# Access Compliance Report

## Public Rights-of-Way

| Intersection ID: 10036601               | Main Street: RUSHMORE_DR | Cross Street: N/A                       | Location: NW           |
| ADA ID: 598F4414161D                    | Ramp Type: PerpDiag      | Initial Pass/Fail: Fail                 | Overall Compliance: No |

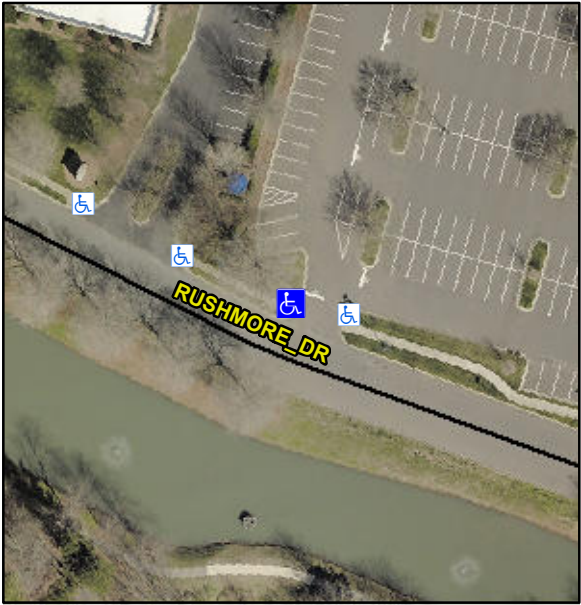
|   | Remove & Replace Curb Ramp With Two New Directional Ramps or Equivalent. | N/A        | Ramp Length (in)      | 95.0  | Yes        | Ramp Slope (%)              | 5.1   |
|   |  | No         | Ramp Width (in)       | 46.0  | No         | Ramp XSlope (%)             | 3.8   |
| <p>Surveyor Notes:</p> <p>N/A</p> <p>PROW/ADA:</p> <p>Not Found, R304.5.1, R304.5.3</p> |  |            | Road Slope (%)        | 2.0   | N/A        | Clear Space?                | N/A   |
